Attachment C: Plan Comparison Table

Approved Plans	Proposed modification plans
Site Plan DA0350/2022 – Revision 3	Site Plan DAM0043/2024 – Revision 07

Level 5 Overall Plan

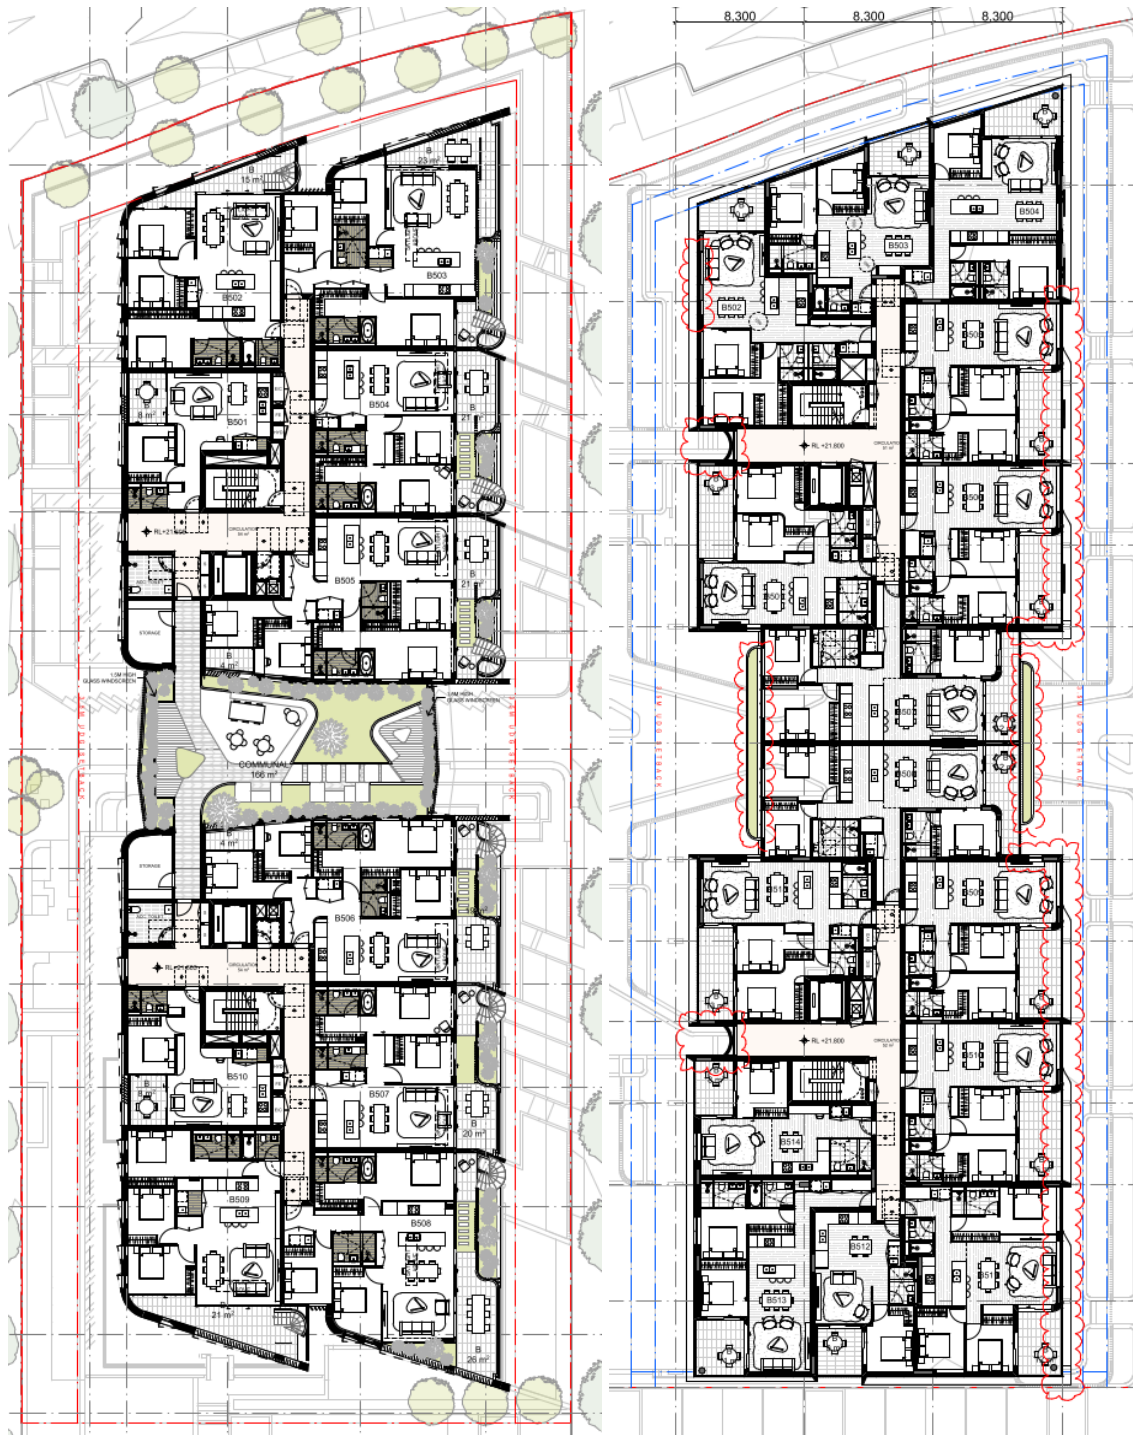
Comment: The modifications to the Level 5 floor plan captures changes to the floor configuration, increase of apartment numbers, and changes to the façade details. Notably, the modification includes removal of communal open space in the centre of the floor plan; Level 5 has been altered to reflect the floor plan of all preceding levels.

Rooftop Terrace

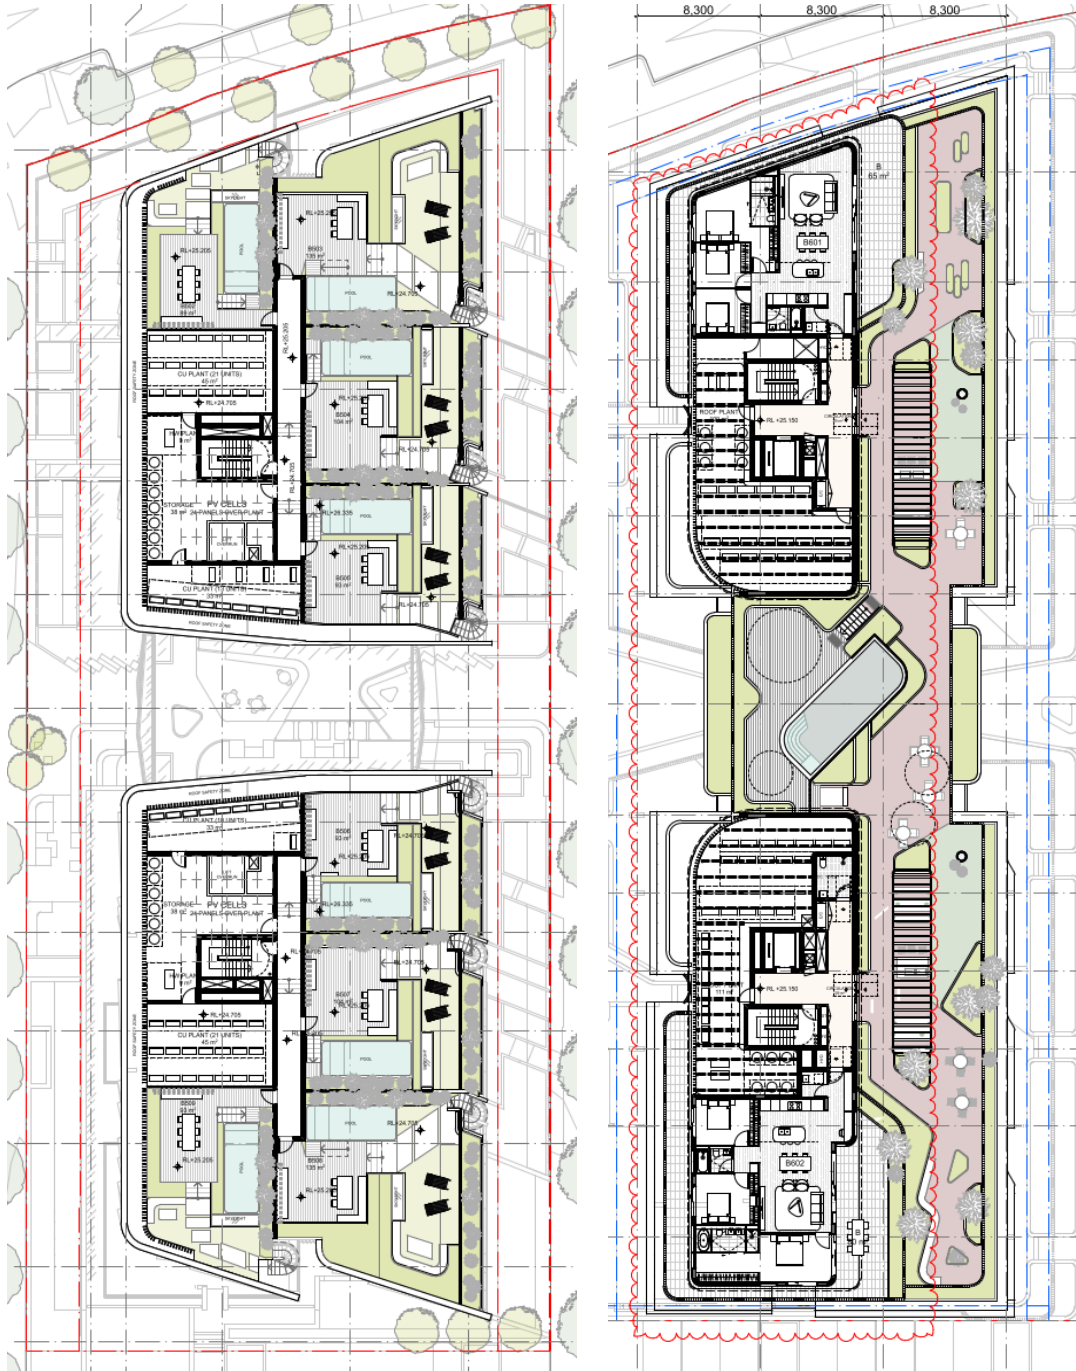
Comment: There are significant modifications proposed to the rooftop terrace. The rooftop terrace is now connected to improve accessibility throughout the building. The rooftop has been reconfigured to remove each individual POS, and introduce a larger rooftop Communal Open Space, utilising one large swimming pool and a connected communal open space with excellent amenity features.

Two 3-bedroom apartment units have also been added to the top floor.

Rooftop Terrace – No Pool Option

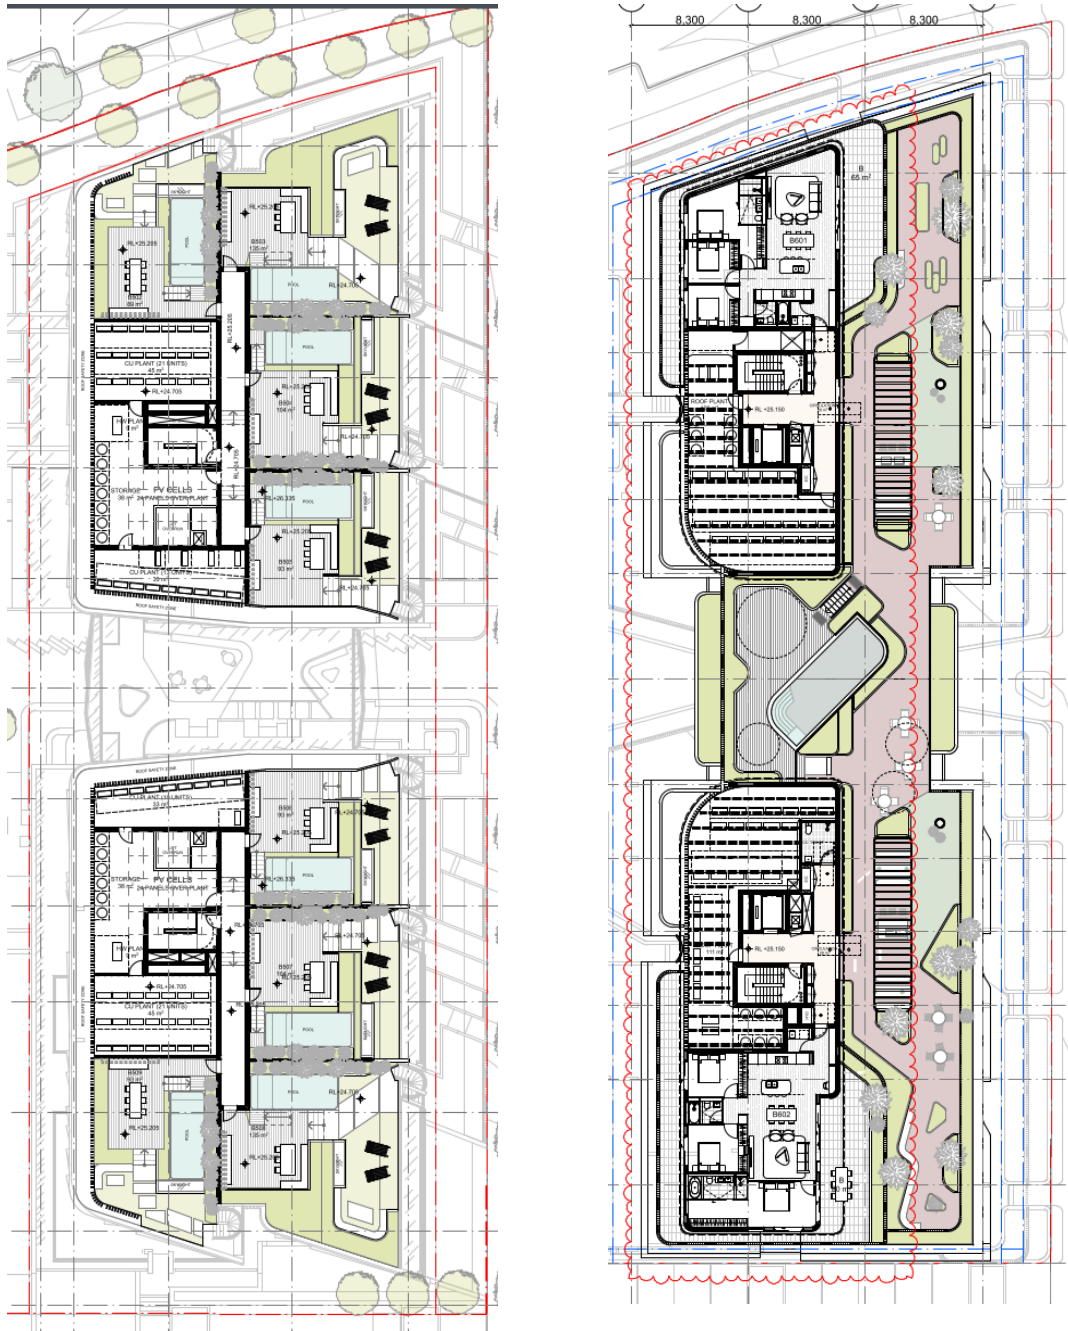
Comment: The proposed modification to the rooftop terrace – no pool option captures the same details as shown in the ‘Rooftop Terrace’ plans described above. It is important to note the ‘no pool option’ shows the removal of pools on Building A, and no modifications are proposed to this arrangement.

Section – Sheet 1 / DA0350/2022 – Revision 06 / N – S Section – Building B

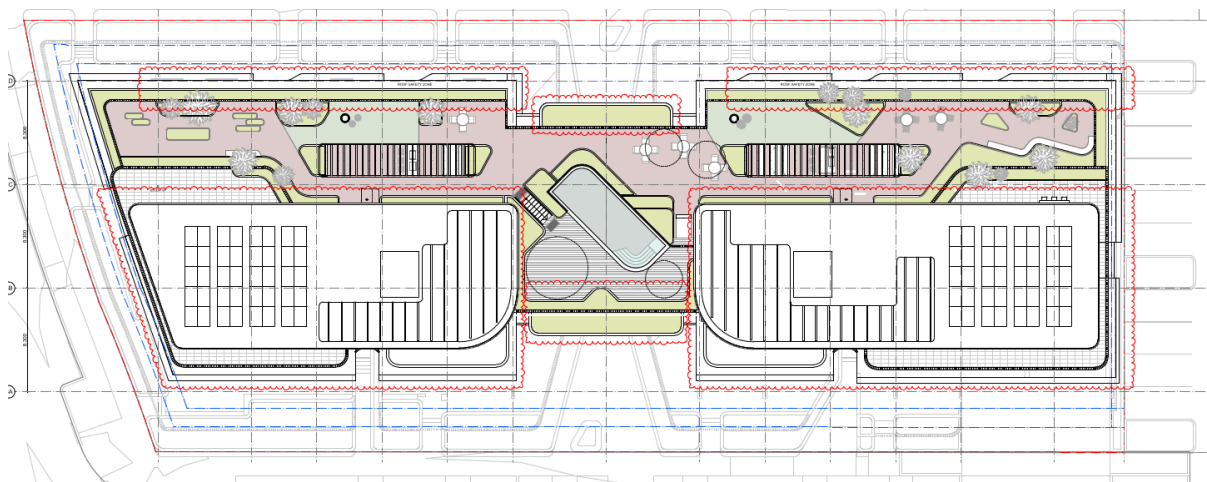
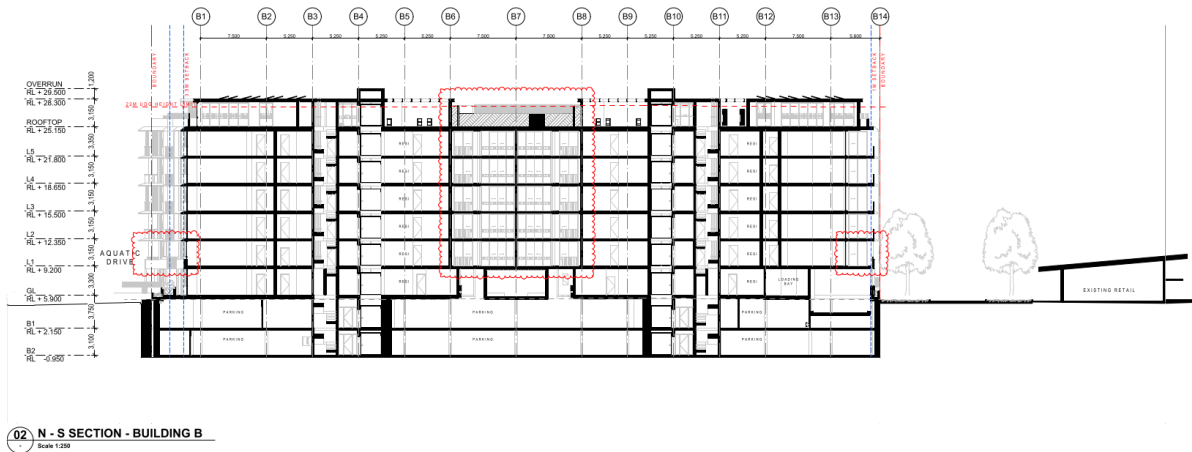
Comments: The modified Section plan shows the expanded Basement 2 floor layout, changes to the location of residential lobbies in the basements and throughout, and general changes to the floor and façade configuration throughout.

The altered loading bay and basement access can be seen on the right side of the elevation.

Modifications to building connectivity on the upper-floor and communal open space are also depicted.

Section – Sheet 2

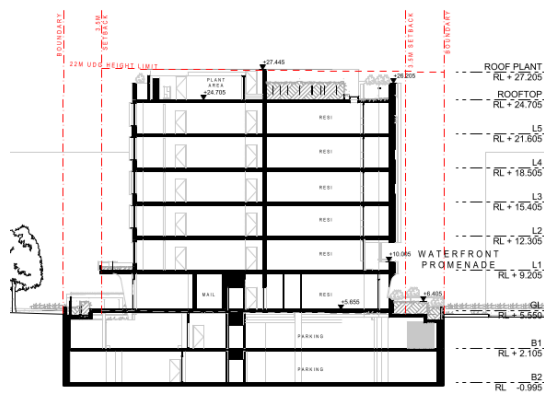
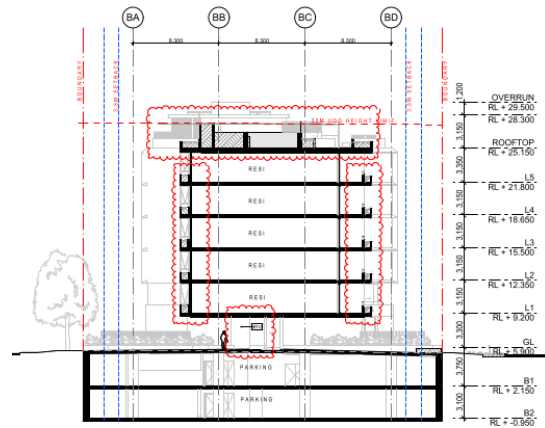
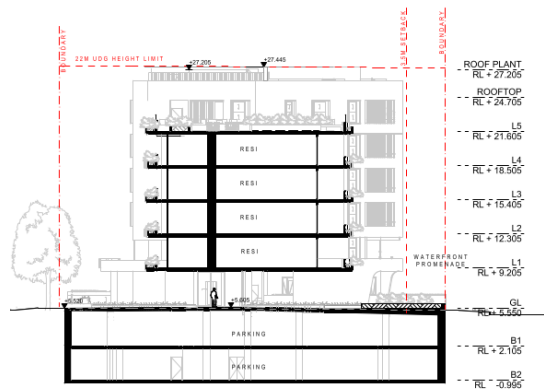
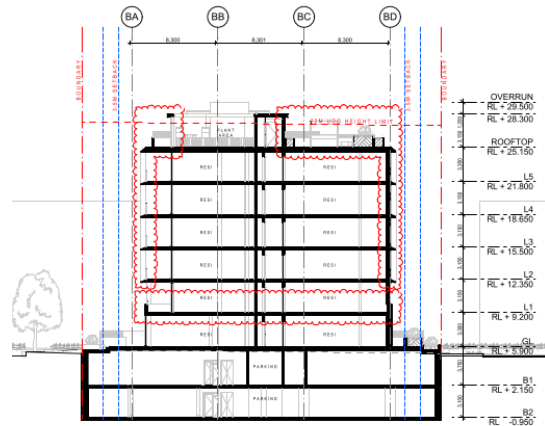
Comments: The modification plans depict changes to the structural sections of the building as a result of the floor plan reconfiguration and other changes. They also depict modifications to the lift design, including an increase in the height variation as a result of the lift overhead and top floor apartments.

Section – Sheet 3

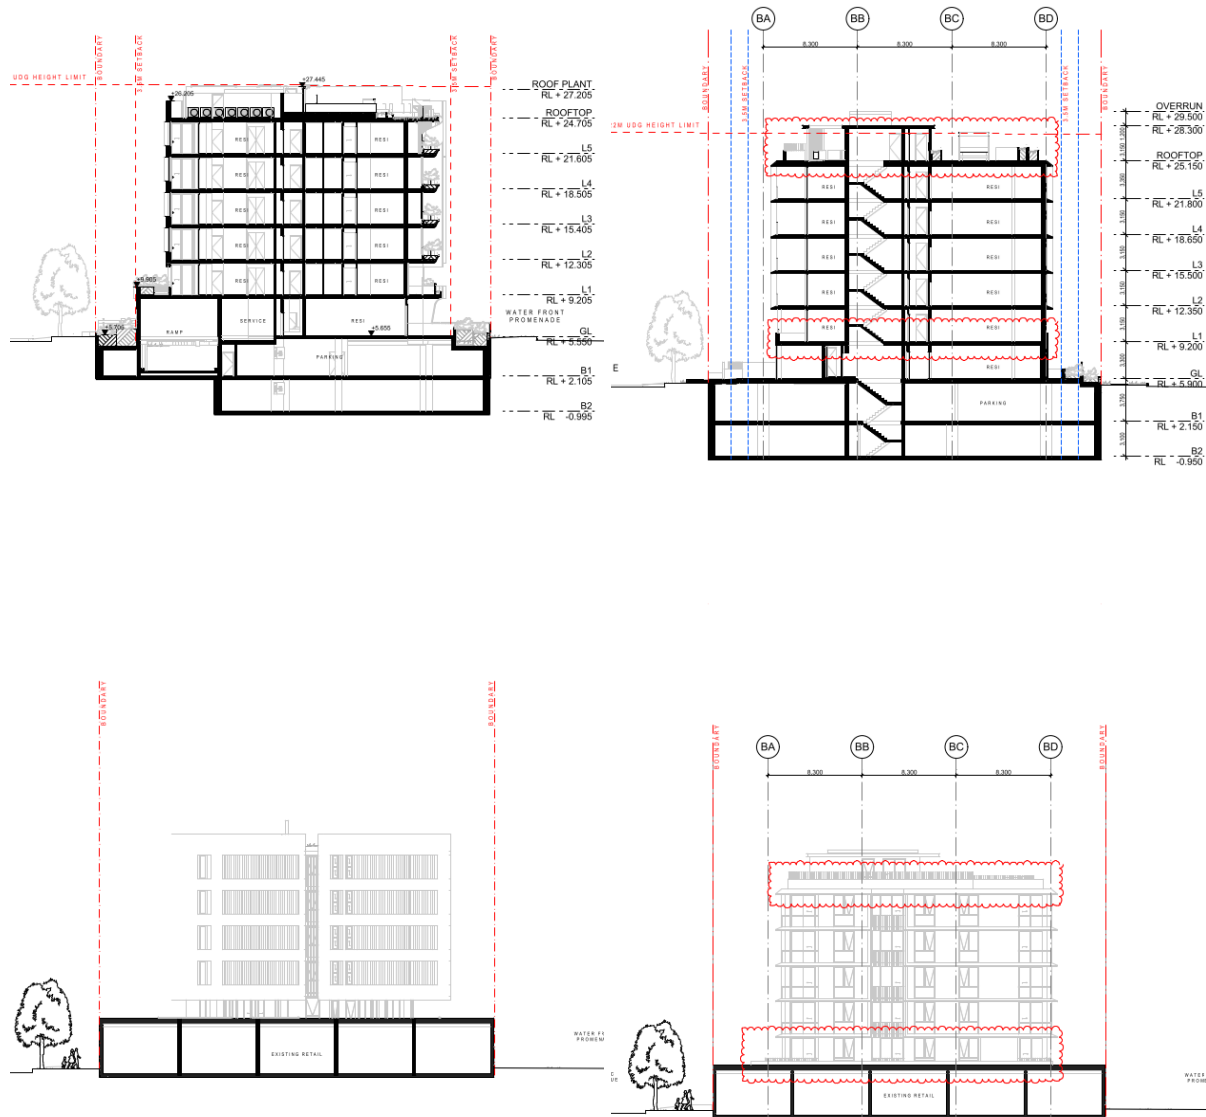
Comment: These plans depict changes to the Building B façade, basement parking, and floor plan configuration throughout the East – West section. Changes to the façade are depicted in the background of the Building C section.

Elevations – North Full Site

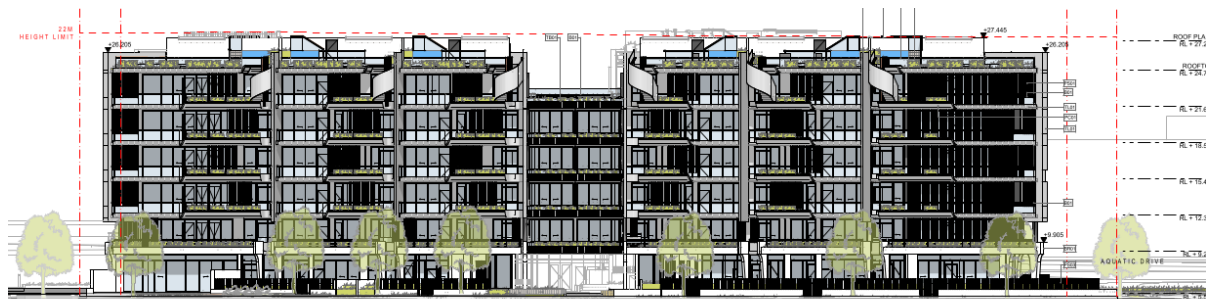
Comment: The north elevation sheet captures modifications to the north façade of Building B. The Modifications include a redesign of the façade to remove tile cladding to incorporate additional windows and articulation features.

Landscape Coversheet / DA0350/2022 – Issue F

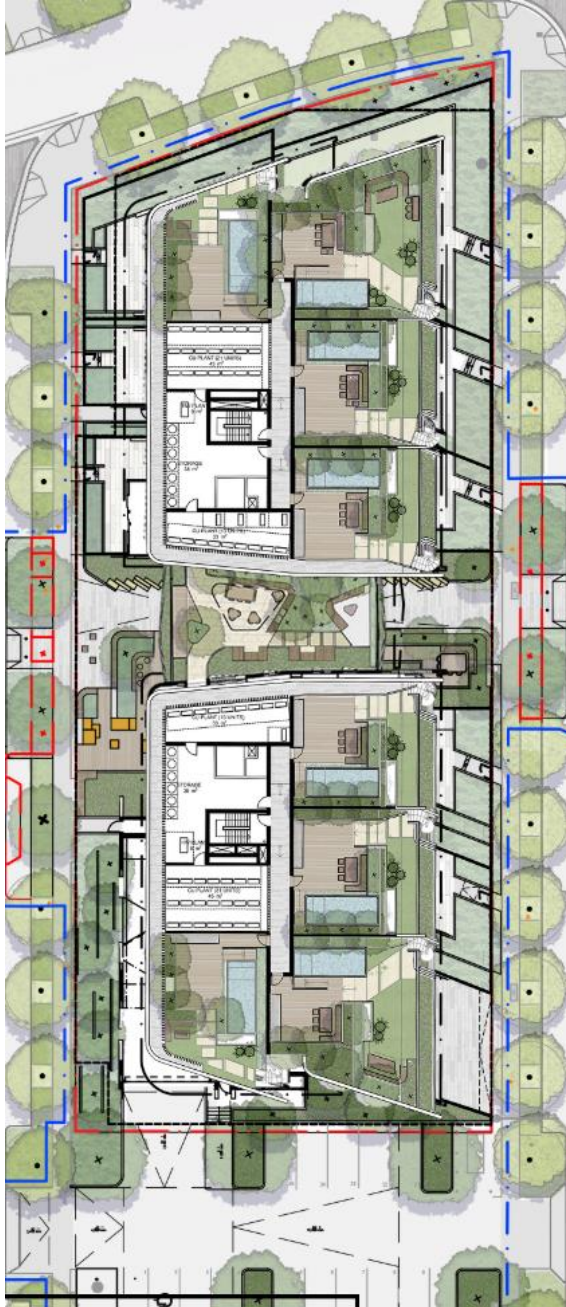
Comment: Updated to capture changes to coversheet details.

Landscape Site Plan Groundfloor

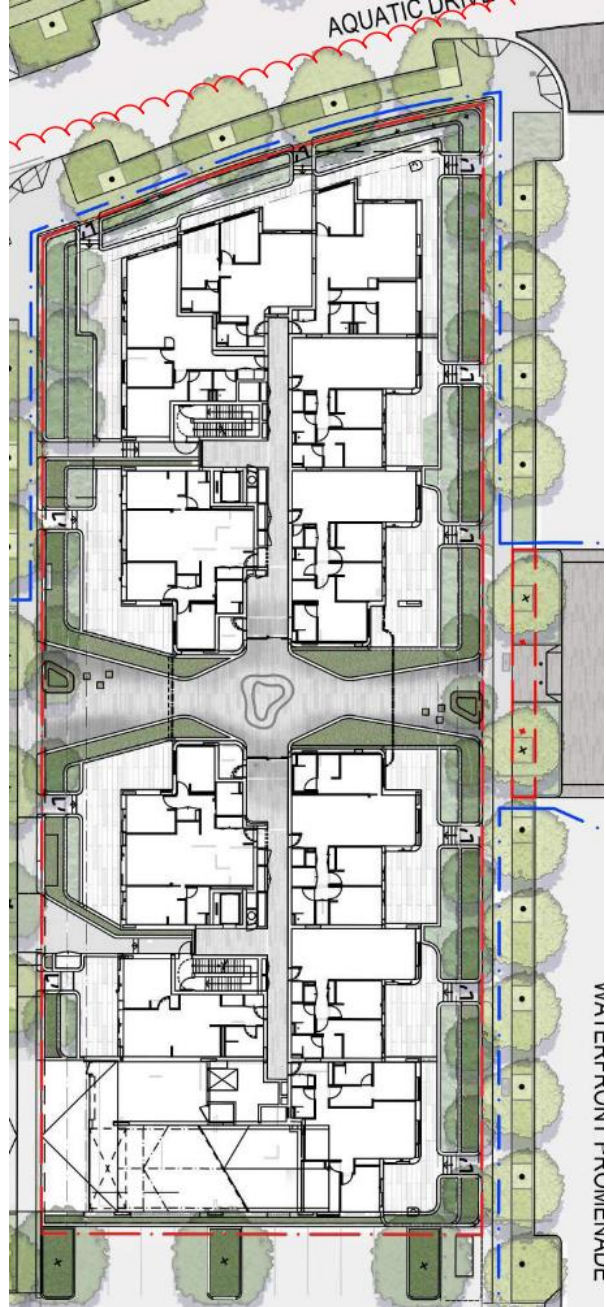
Comment: The modified landscape site plan depicts changes to the ground-floor and roof-plan landscaping layout.
